APP/14/00286

PLAN-005806

Proposal: Retention and erection of fencing as an alternative to the boundary treatments agreed under Planning Permission APP/10/00158.
Site: Development plots 1-3 at 64-66 Hazleton Way, Waterloo, PO8 9BT.
APP/14/00286

Southern Water MapGuide Browser

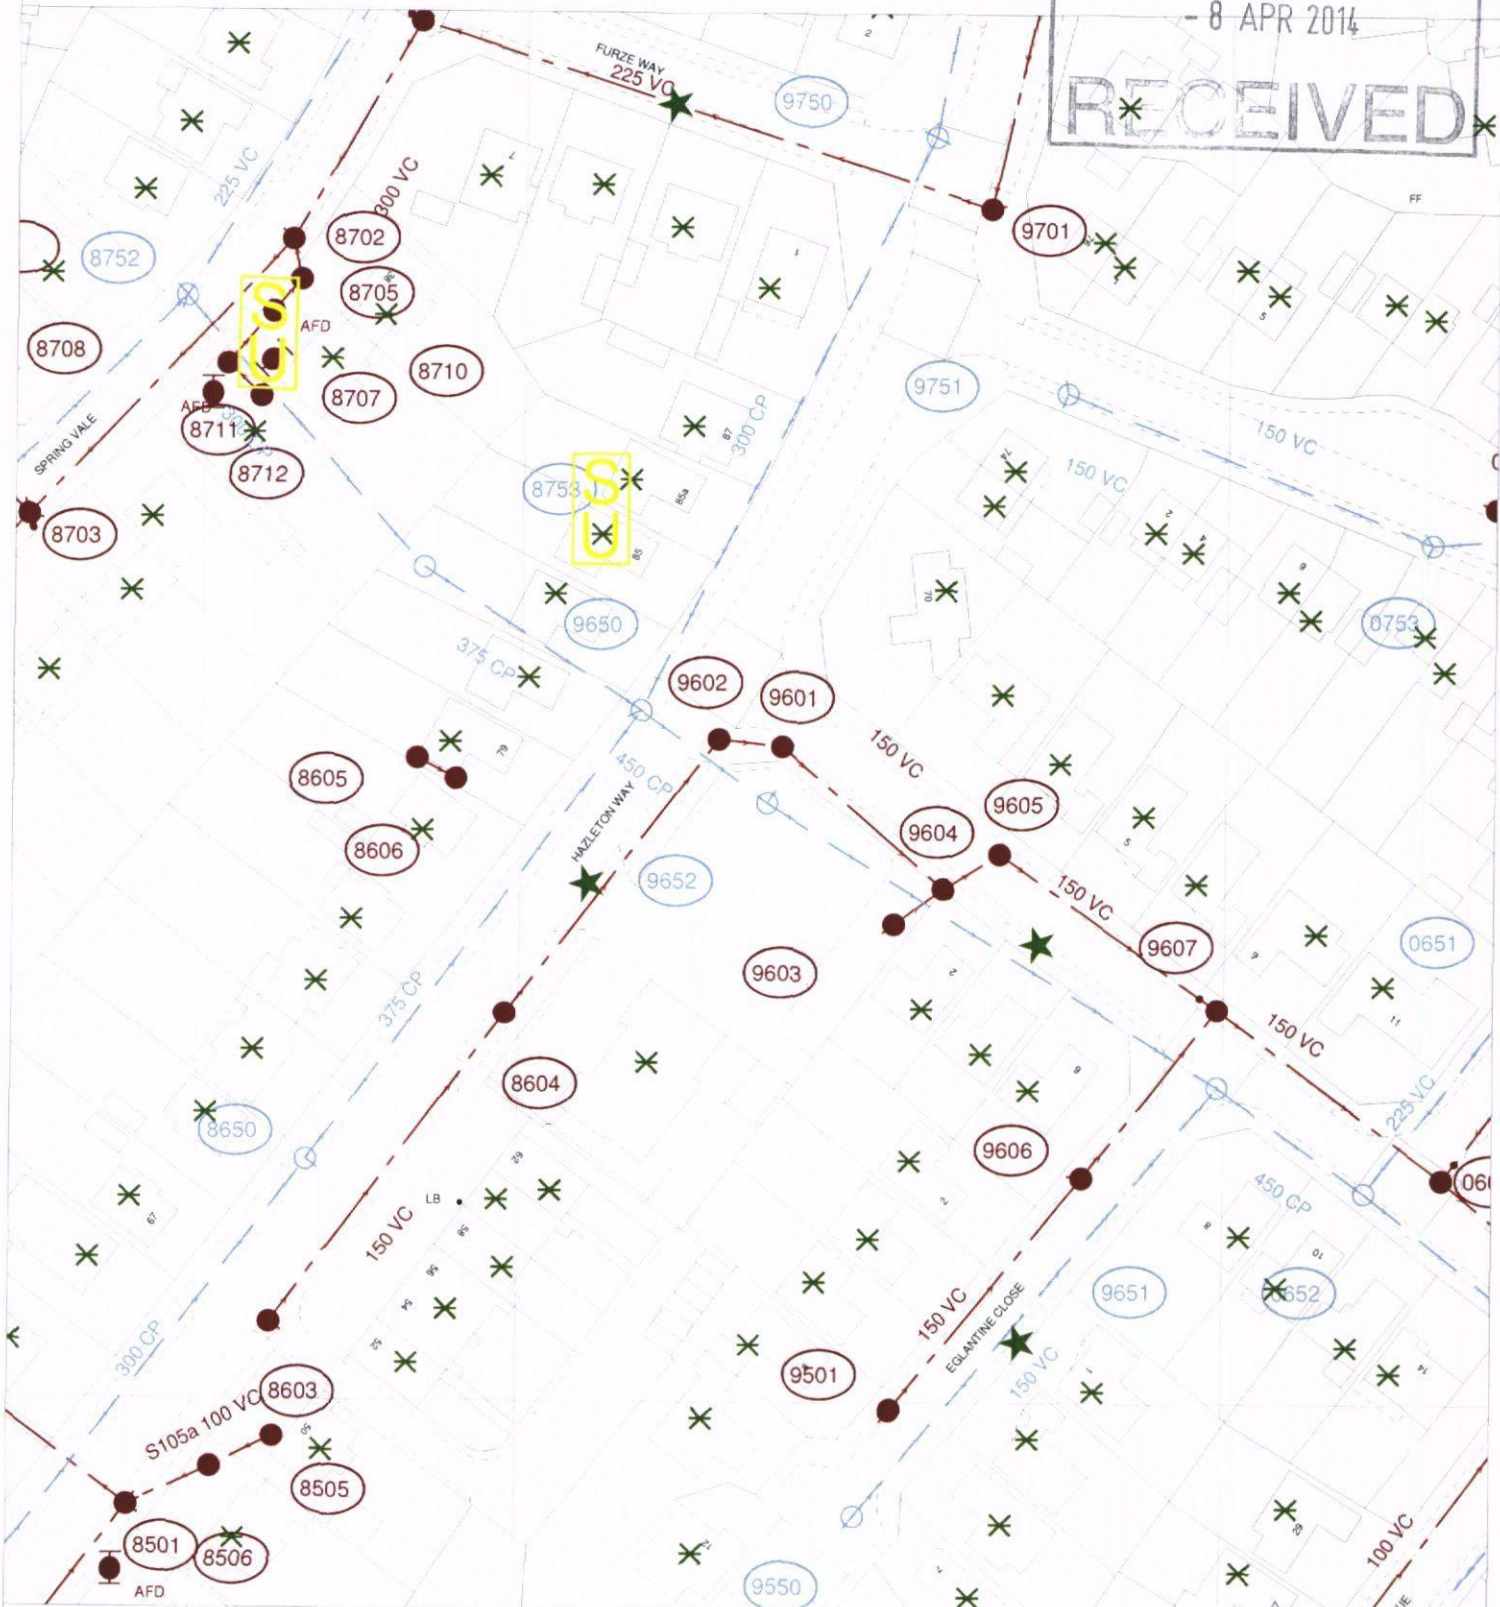
Please find attached a plan of the sewer records showing the approximate position of surface water sewer crossing the site and foul sewer within the site. The exact position of the foul and surface water sewer must be determined on site by the applicant.

- No excavation or new tree planting should be located within 3.5 metres either side of the centreline of the surface water sewer.
- No excavation or new tree planting should be located within 3 metres either side of the centreline of the foul sewer.
- No new soakaways should be located within 5m of a public sewer.
- All existing infrastructure should be protected during the course of construction works.
